Dr. Jacob Paz
402 Greenbrier St # 47
DeRidder, LA 70634

U.S. Nuclear Regulatory Commission
Mail Stop O-16G4
Washington, DC 20555-0001

July, 28 2008

A Review of Health Risks due to Complex Mixtures in a Geologic Nuclear Waste Repository

Figure 1. Generalized relationship of radiological and chemical risk at nuclear waste (Persson 1990)

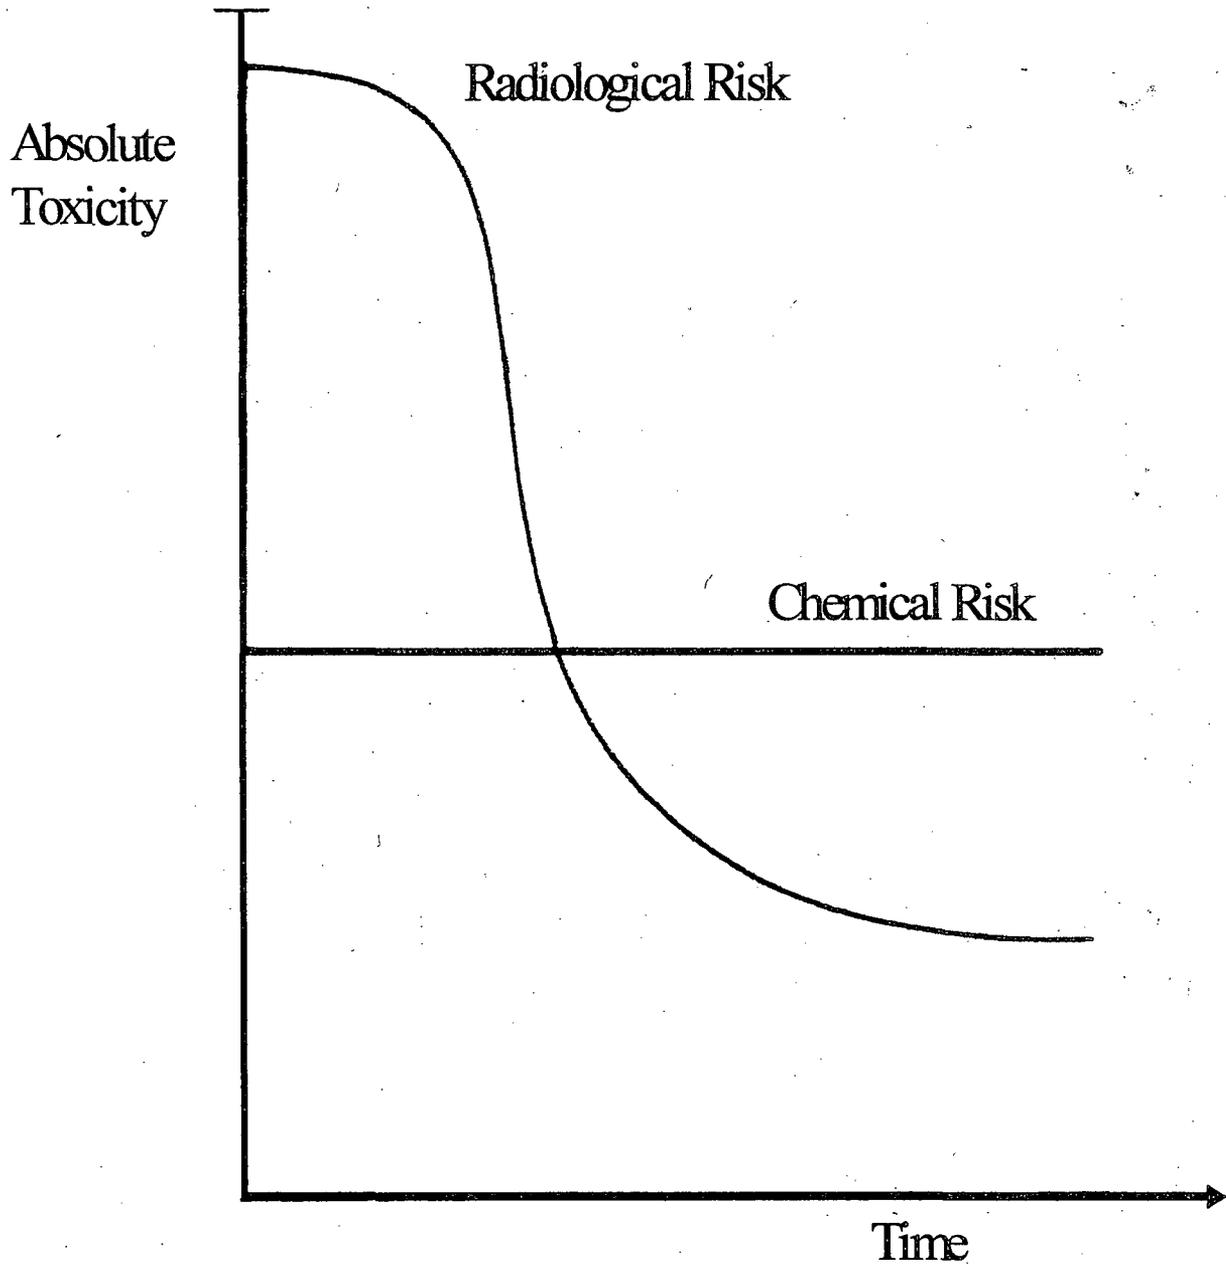
In contrast, to (Persson 1990) statement that absolute chemical toxicity will remain constant at a high level nuclear repository, the authors believe as time progresses the absolute toxicity will increase due to: First, the authors believes that there will be an increase in the magnitude of the absolute toxicity due to synergistic interactions among Cr, Ni, Ni, and Ti heavy metals however no value can be set. Another aspect (is it shown in Figure 2. Shows there are possibility synergetic interactions between Ni and Cr both known potent carcinogens and subsequently increase in cancer risk. We can not assign a value for the health risk because of lack of applicable data. Finally, the conversion of actinides into Pb, eventually could also increased the again the chemical toxicity will start to increase as time progresses. The decay of actinides, such as uranium and plutonium, in the fuel will result in the formation of significant quantities of lead in repository as time progresses. For every metric ton of buried waste (Pu) 325 grams of lead will be produced within a one million years. For a repository containing 77,000 metric tons of waste, over 25 metric tons of lead will be created by decay. In addition, as it shown in figure 3, spent nuclear fuel within a high-level nuclear waste repository will radioactively decay producing new nuclides.

Figure 2. Hypothetical changes in absolute chemical risk in a geological repository due to interactions among Cr, Ni, and Ti, and the Conversion of Actinides into Pb.

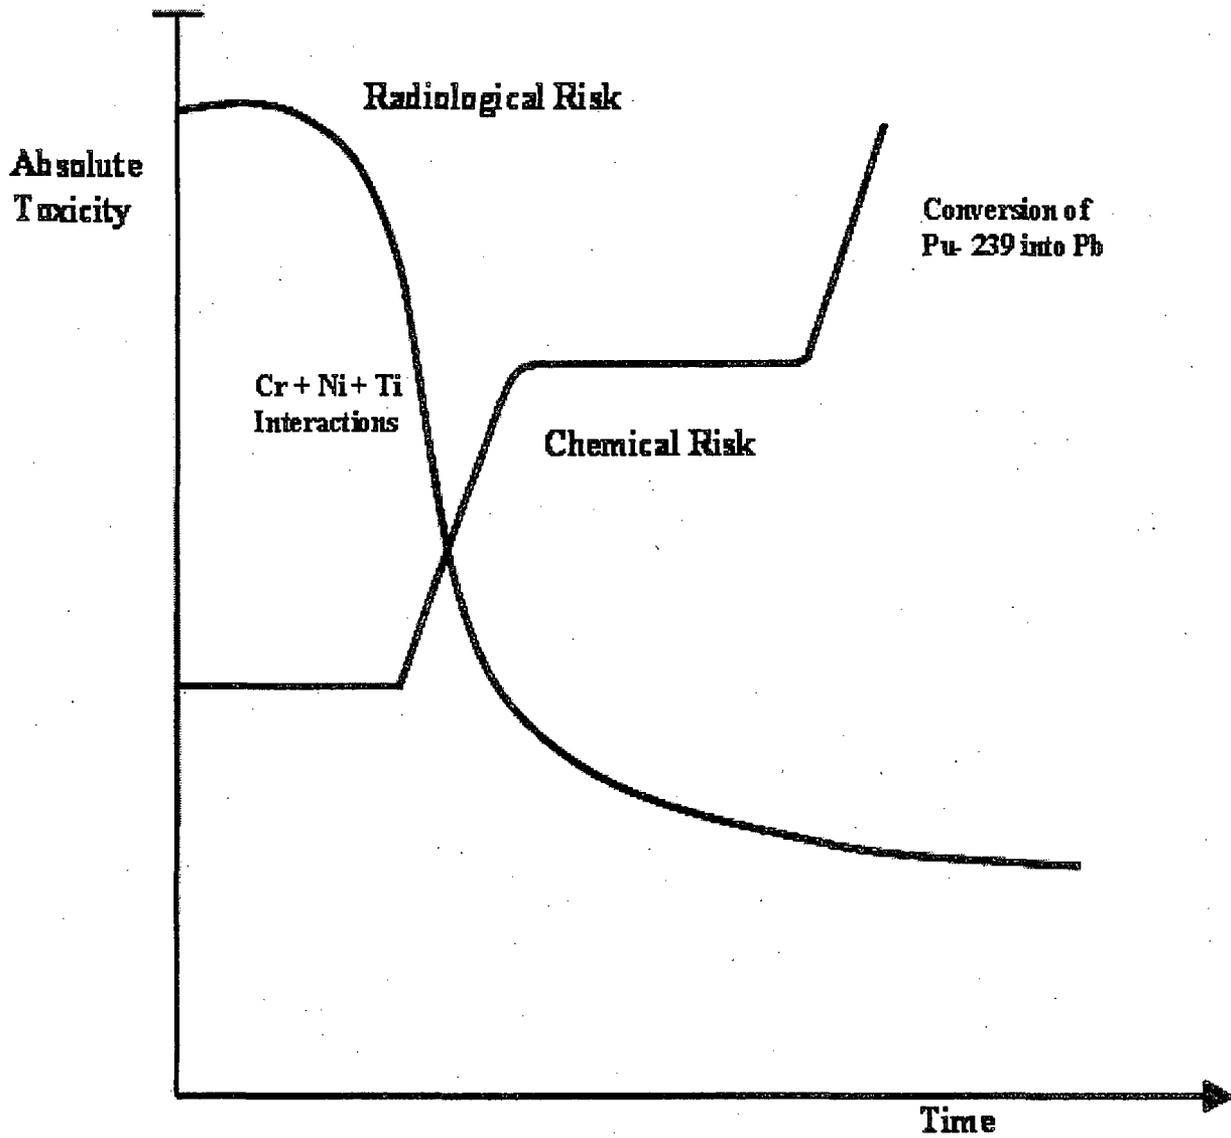
Fig.2. Shows changes in absolute chemical risk in a geological repository due to the possible synergistic interactions among heavy metals and possible synergistic interaction between Ni, Cr and Ti both known carcinogens, and the Conversion of Actinides (^{239}Pu into Pb).

Figure 3. Illustrate the Calculated Radioactive Decay of Plutonium into Lead in Spent Nuclear Fuel at a Nuclear Repository

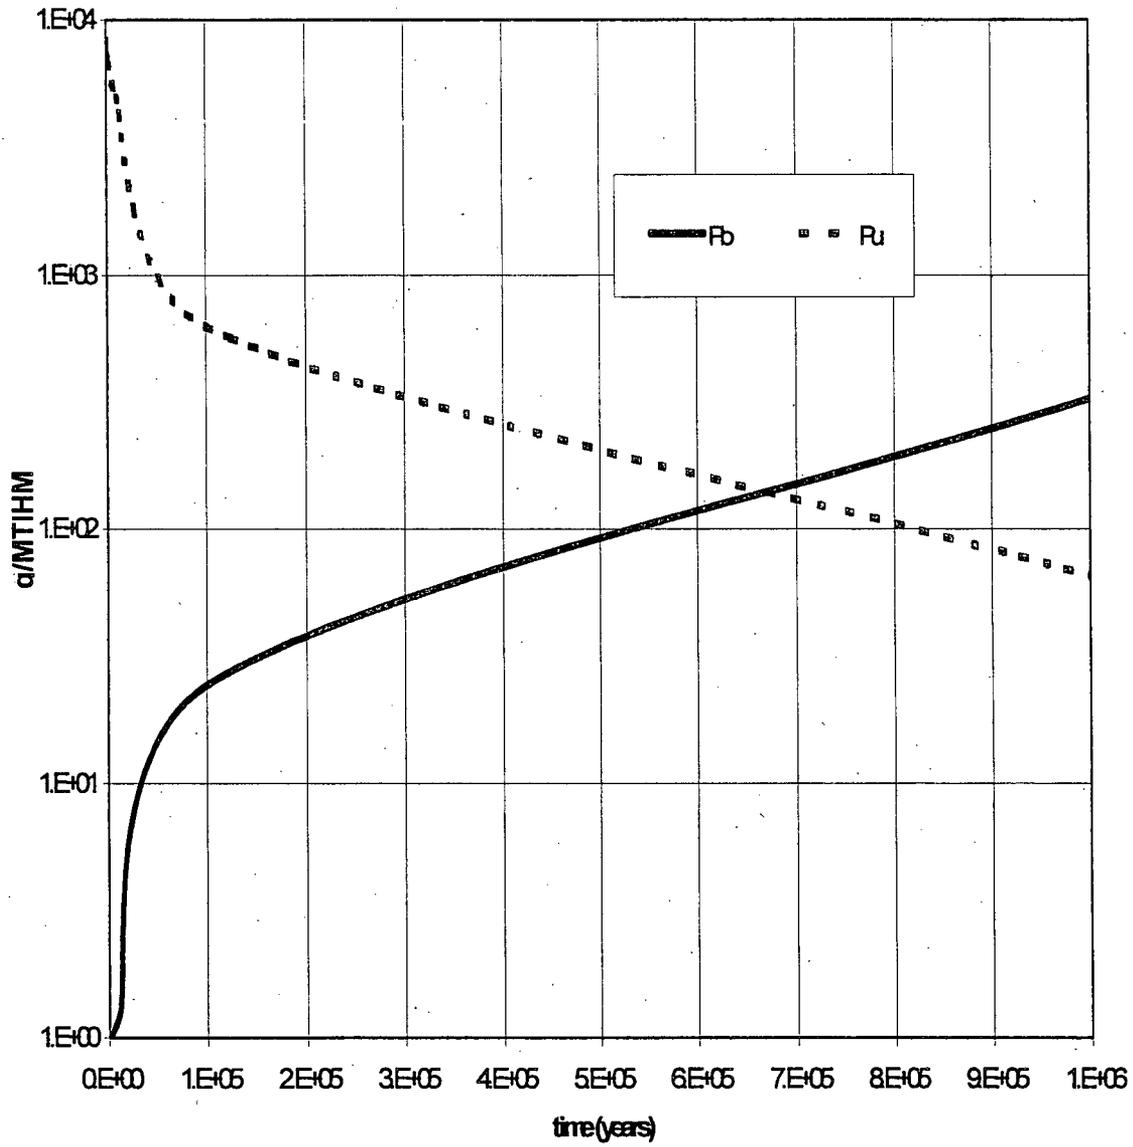
Figure 3 Illustrates the Calculated Radioactive Decay of ^{239}Pu into Lead in Spent Nuclear Fuel at a Nuclear Repository.

The decay in the fuel of actinides, such as uranium and plutonium, will result in the formation of significant quantities of lead in the repository as time progresses. For every metric ton of buried waste (^{239}Pu) 325 grams of lead will be produced within one million years. For a repository containing 77,000 metric tons of waste, over 25 metric tons of lead will be created by decay.
